**PSE Autoclass SD
(New Figure, 33.2.5.12)**

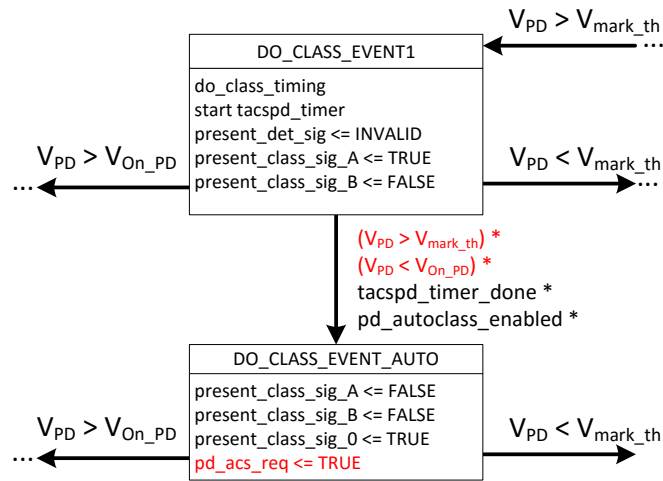
Define new variable (33.2.5.9):

MirroredPDAutoclassRequest

A control variable output by the PSE power control state diagram that indicates whether the PSE has received an Autoclass measurement request from the PD via the Data Link Layer. See 33.5.

Define new timer (33.2.5.10):

tauto_pse1_timer

A timer used to delay Autoclass power measurement following transition into state POWER_ON; see $T_{\text{AUTO_PSE1}}$ in 33.2.7.3.

tauto_pse2_timer

A timer used to limit Autoclass power measurement following transition into state POWER_ON; see $T_{\text{AUTO_PSE2}}$ in 33.2.7.3.

PD Autoclass SD
(Modify Figure, 33.3.3.11)

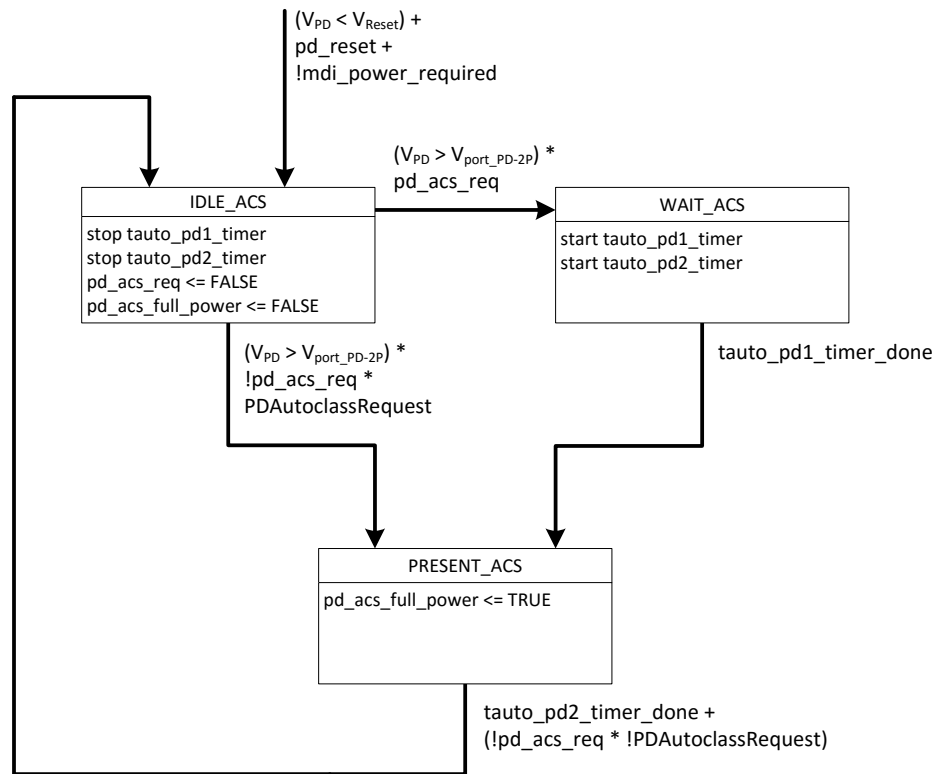
Define new variables (33.3.3.8):

pd_acs_req

This variable indicates whether the PD performs an Autoclass request during Physical Layer classification. See 33.3.6.3.

pd_acs_full_power

This variable indicates whether the PD is required to draw maximum power, $P_{\text{Autoclass_PD}}$. See 33.3.6.3.

PDAutoclassRequest

A control variable output by the PD power control state diagram indicating whether the PD requests Autoclass via the Data Link Layer. See 33.5.

PSE DLL Autoclass Control SD
(Replace Figure 33-47, 33.5.3.6)

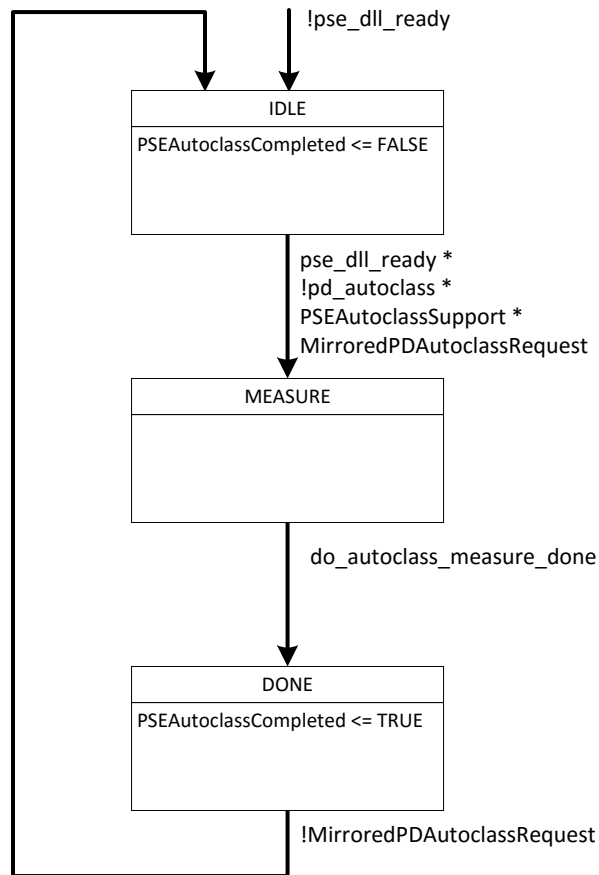
Define new timers (33.3.3.9):

tauto_pd1_timer

A timer indicating maximum delay until start of Autoclass power draw. Applies to Autoclass requests by Physical Layer classification; see $T_{\text{AUTO_PD1}}$ in 33.3.6.3.

tauto_pd2_timer

A timer indicating minimum delay until end of Autoclass power draw. Applies to Autoclass requests by Physical Layer classification; see $T_{\text{AUTO_PD2}}$ in 33.3.6.3.

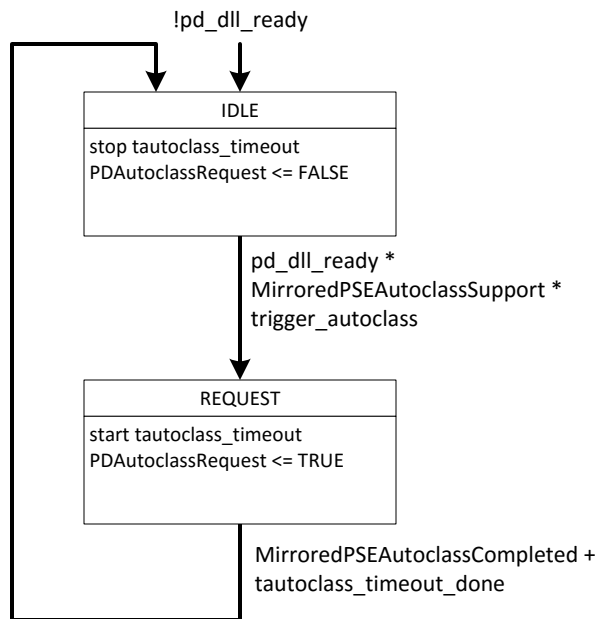
Define new variable (33.2.5.9):

pd_autoclass

A control variable output by the Type 3 and Type 4 PSE state diagram indicating whether the PSE has observed an Autoclass measurement request during Physical Classification. See 33.2.5.9.

Define new function (33.2.5.11):

do_autoclass_measure

A function defined in the Type 3 and Type 4 PSE state diagram, measuring $P_{\text{Autoclass}}$ as defined in 33.2.7.3.
